ENGINEERING RECORD DRAWINGS

CLEARWAY, LOT 5

CONSTRUCTION PLANS

CLEARWAY, LOT 5
6365 E. PLATTE AVENUE, COLORADO SPRINGS, CO
SITE GRADING PLAN

PROJECT NO. 44-042A
DESIGNED BY: DLM
DRAWN BY: CLP
CHECKED BY: DLM
DATE: 06/13/2023
SCALE: HORIZONTAL: 1"=50' VERTICAL: 1"=5'
SHEET 15 OF 16
BMP02

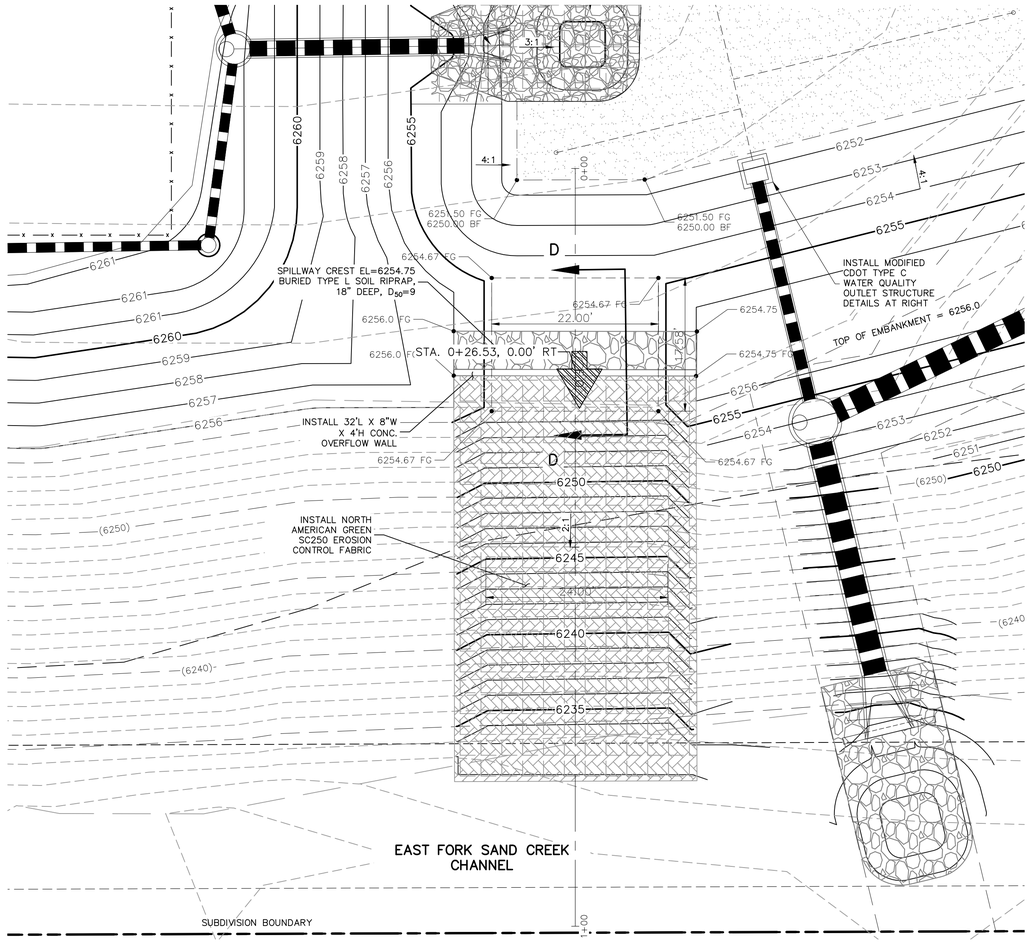
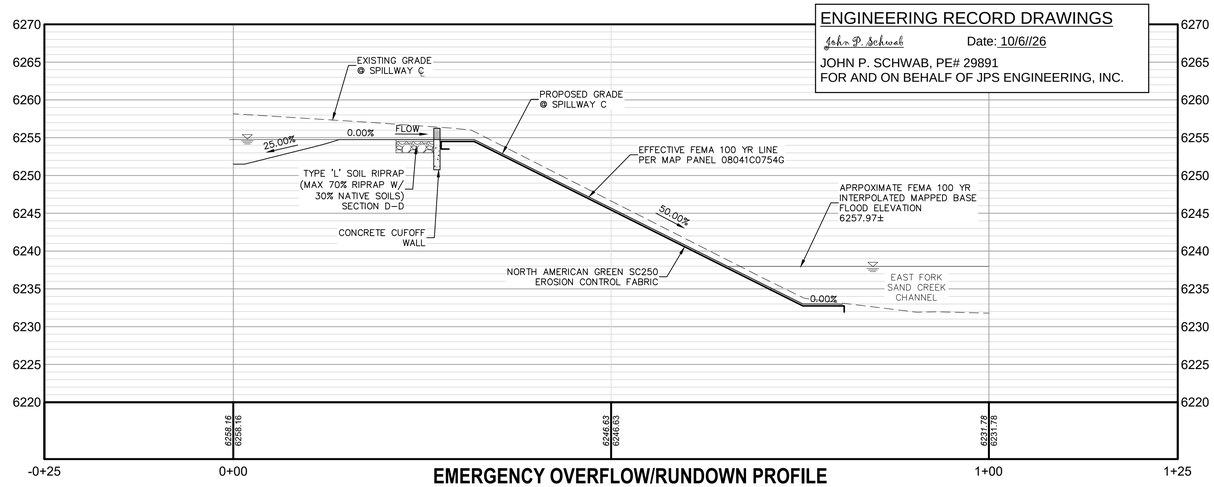
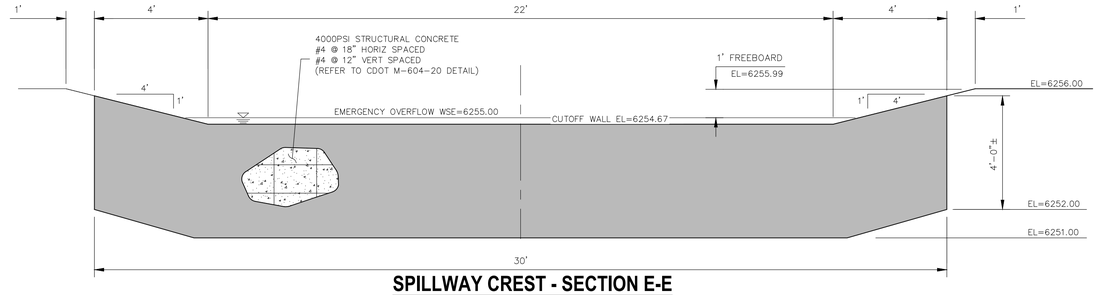
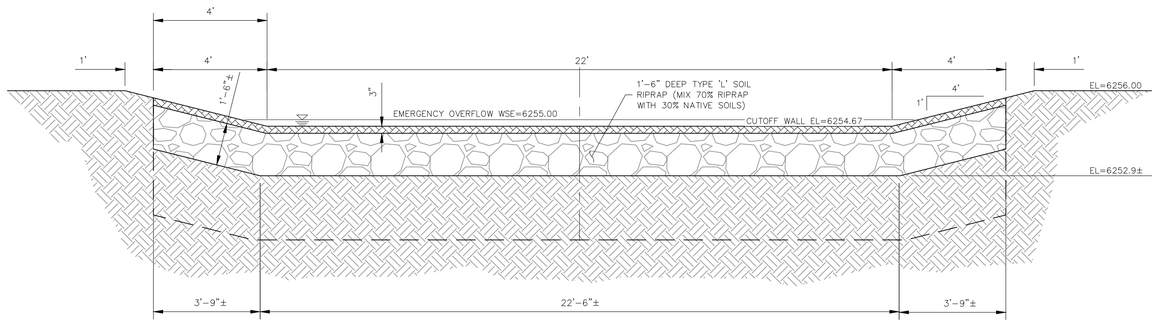
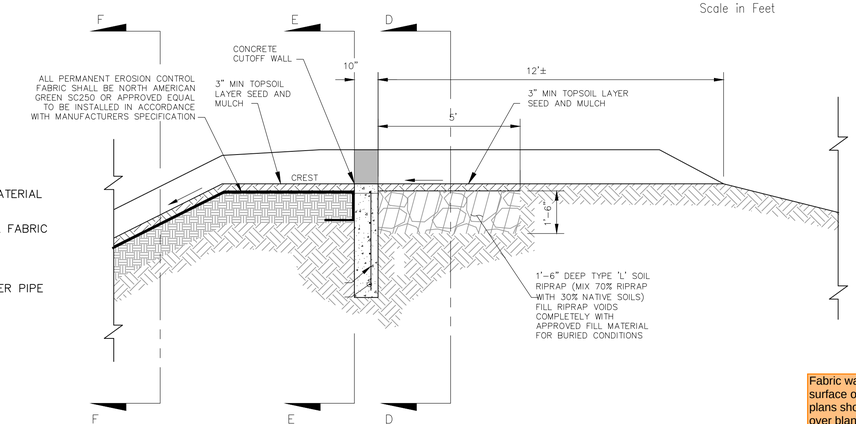
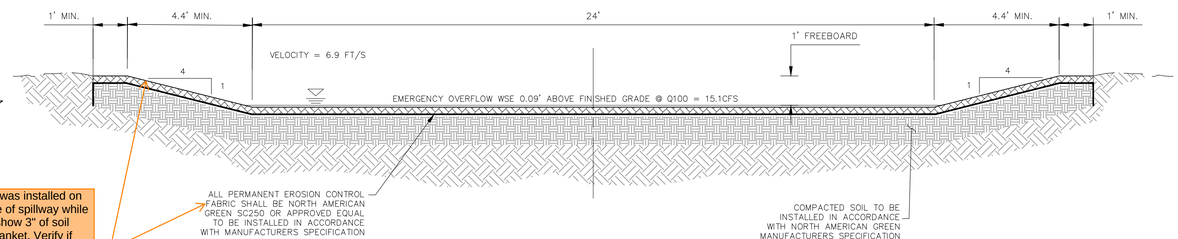
Fabric was installed on surface of spillway while plans show 3" of soil over blanket. Verify if blanket can be placed on surface.

MAINT AND ACCESS ROADWAY PLAN

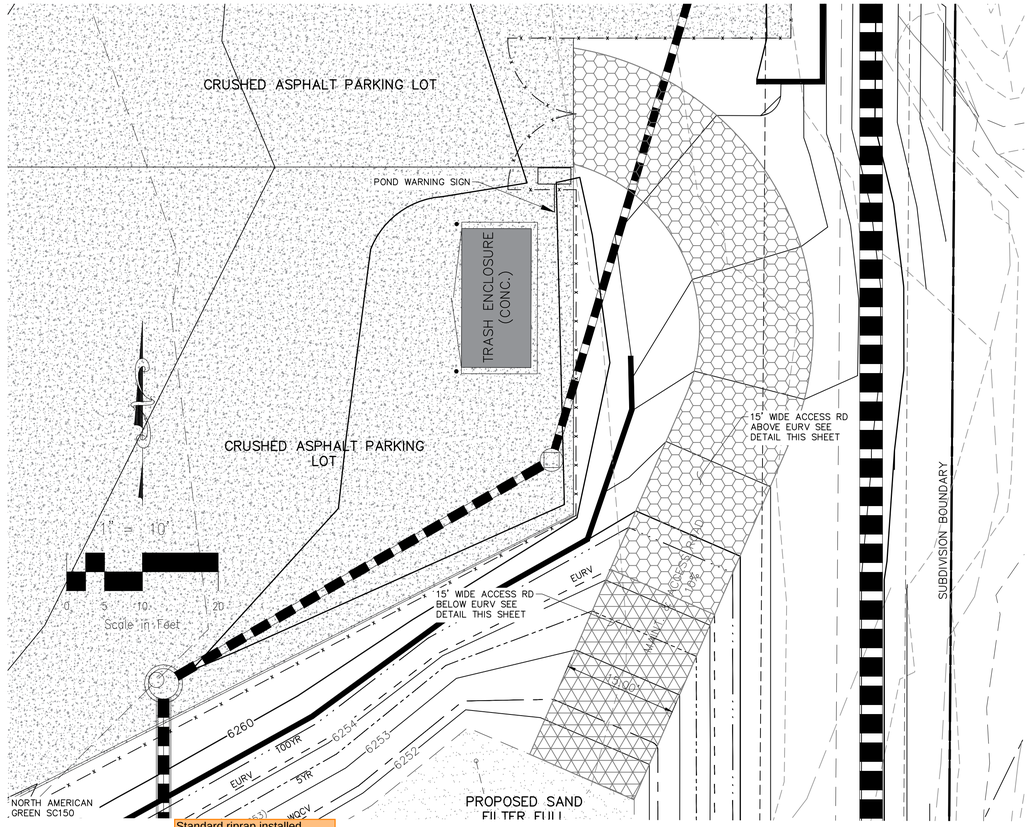
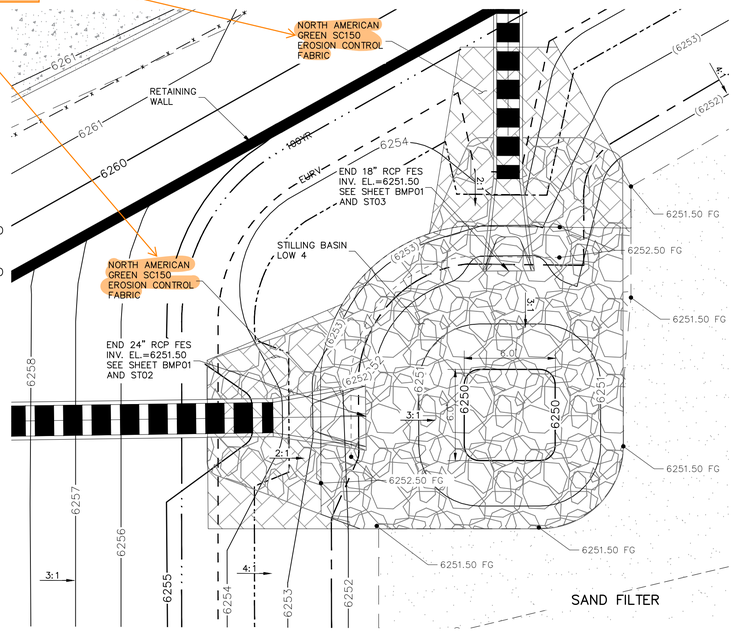
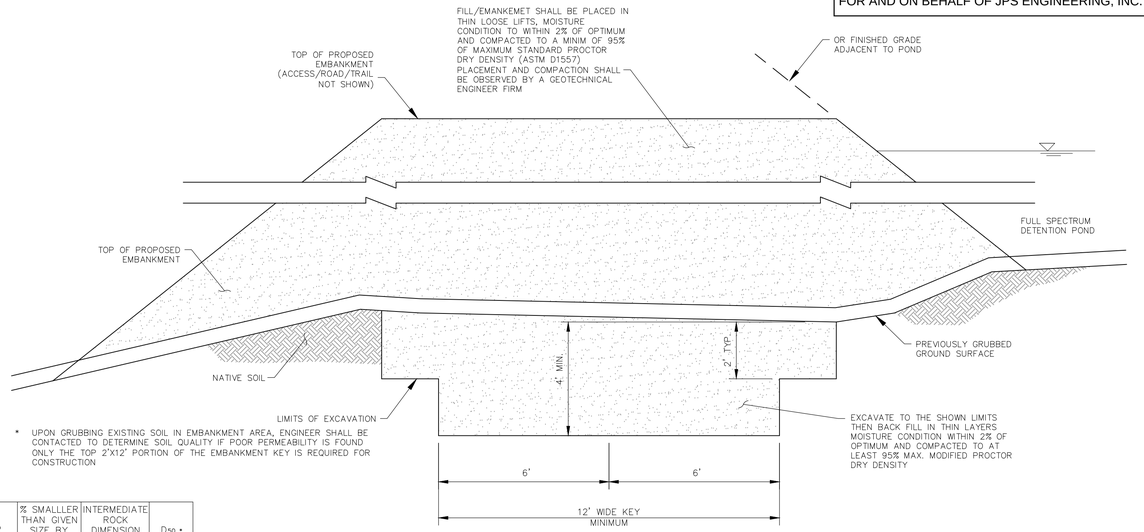
Standard riprap installed instead of TRM in field. Please reflect changes on plans or resolve in the field.

Sheet BMP01 states access road is 11', and the road measures 11' in field. Please confirm/revise.

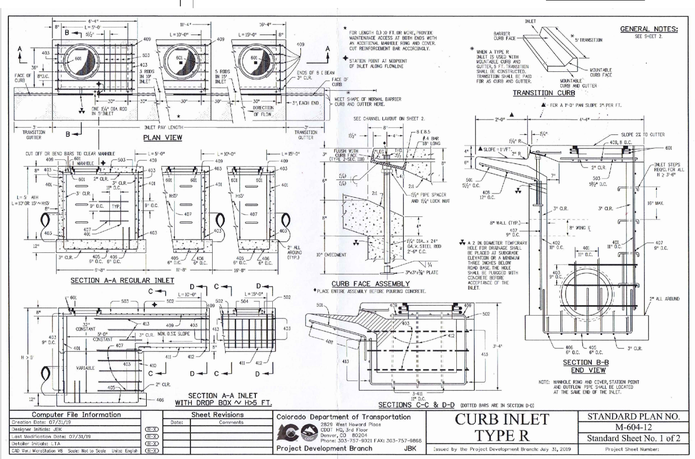
Approved drainage report shows flows from this area going off-site (DP15). Please revise pond calculations to include this additional area, or revise grading in field to match original plans.

Void filled riprap called out in plans, plain riprap installed in field.

TRM was specified above the outlets on sheets in the drainage report. No TRM installed in field. Verify if TRM is necessary for these slopes.

TRM was specified above the outlets on sheets in the drainage report. No TRM installed in field. Verify if TRM is necessary for these slopes.
